RIVERWOOD SUBDIVISION, PHASE II

APPLICATION NUMBER 20 DATE December 4, 2003
APPLICANT Riverwood Subdivision, Phase II
REQUEST Subdivision

DETAIL SITE PLAN

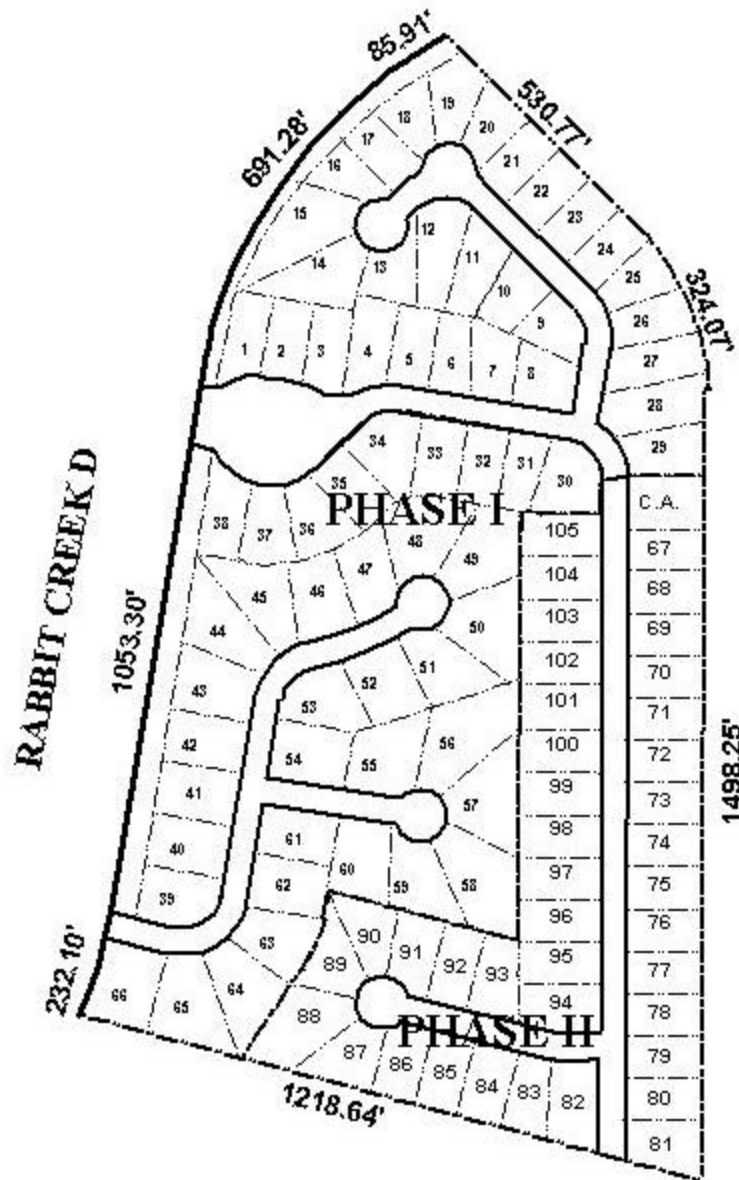
A note should be placed on the final plat stating that lots located on a corner (Lots 82 and 94) are allowed one curb cut each, with the design, size and location to be approved by County Engineering. Additionally, the proposed layout creates a long "straight a way" and a traffic calming device (traffic circle) should be provided in the area of Lots 73 and 74.

Common areas are shown on the plat, thus the placement of a note on the final plat stating that maintenance of all common areas shall be the responsibility of the property owners, should be required.

The 25-foot minimum setback lines are not shown but would be required on the final plat.

With modifications, the plat meets the minimum requirements of the Subdivision Regulations and is recommended for Tentative Approval subject to the following conditions: 1) placement of a note should on the final plat stating that corner lots (82 and 94) are limited to one curb cut each, with the design, size and location to be approved by County Engineering; 2) the provision of a traffic circle in the area of Lots 73 and 74; 3) all common areas be indicated on the final plat with a note stating that the maintenance thereof is the responsibility of the property owners association; and 4) the placement of a note on the final plat stating that any lots which are developed commercially and adjoin residentially developed property must provide a buffer, in compliance with Section V.A.7. of the Subdivision Regulations.
